COACH MODEL : TX40 & TX45

DATE : 6/09/2015

SUBJECT : SOS Symbol Intermittently Appear in Display When Driving in Rain

NOTE: Looking from under coach upward inside left tag above mud flap

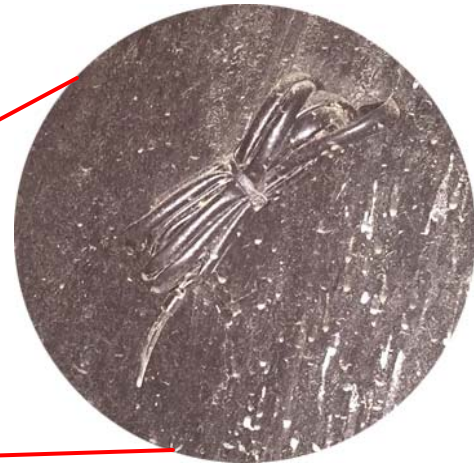
If an intermittent "SOS symbols (passengers emergency signal)" appear in display, especially under wet condition, on some coaches there may be a wire bundle located at road side tag wheel above the mud flap that are not used. This bundle may become frayed with wear over time and susceptible to shorts due to water intrusion. The compromised wires result in a visual and audible "SOS symbols" in the dashboard display. In the event of a nuisance "SOS symbols", this wire bundle should be the first step in trouble shooting.

If wire bundle is present, cut off excess wire and insulate each wire and heat shrink wires to protect against road debris and water causing false "SOS symbols" request in display.
